MIL-H-1237C
 AMENDMENT - 2
20 October 1967

MILITARY SPECIFICATION

HINGES, BUTT (FOR SHIPBOARD USE)

This amendment forms a part of Military Specification MIL-H-1237C, dated 26 March 1962, and is mandatory for use by all Departments and Agencies of the Department of Defense.

FIGURE 5 - LAYOUT OF TYPE II, CLASS I, STYLE B, $3\frac{1}{2}$ " X 3"
 HINGE FOR METAL JOINER DOORS

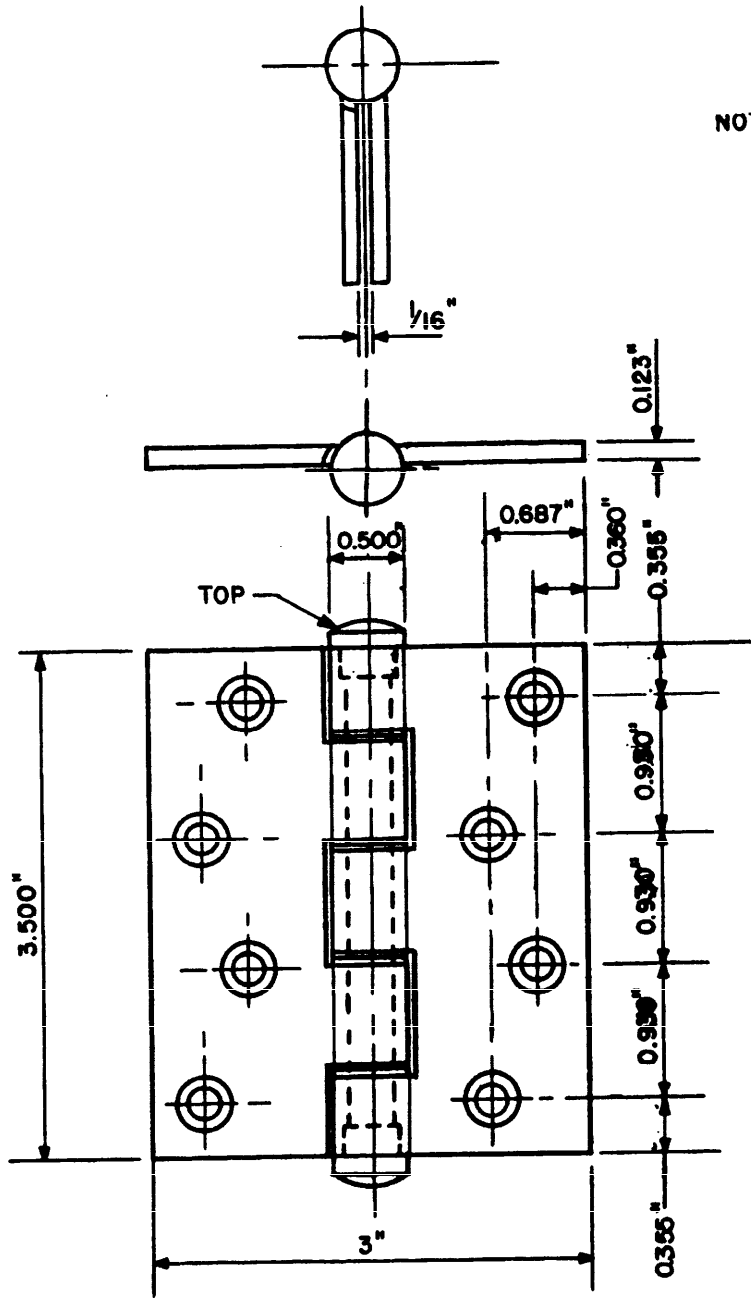
Page 6, add new paragraph 3.11.1:

"3.11.1 Type II, class 1, style B, $3\frac{1}{2}$ x 3 inch hinges, when ordered for metal joiner doors, shall be fitted with nylon shoulder bushings in each knuckle and shall be drilled for eight No. 10-24 screws in accordance with Figure 5. Screws shall be No. 10-24 UNC 2, flat undercut-head, $\frac{1}{2}$ inch long, brass, dull chrome US 26D finish."

Add Figure 5.

NOTE: PROVIDE
 8 HOLES FOR # 10-24
 UNC FHMS
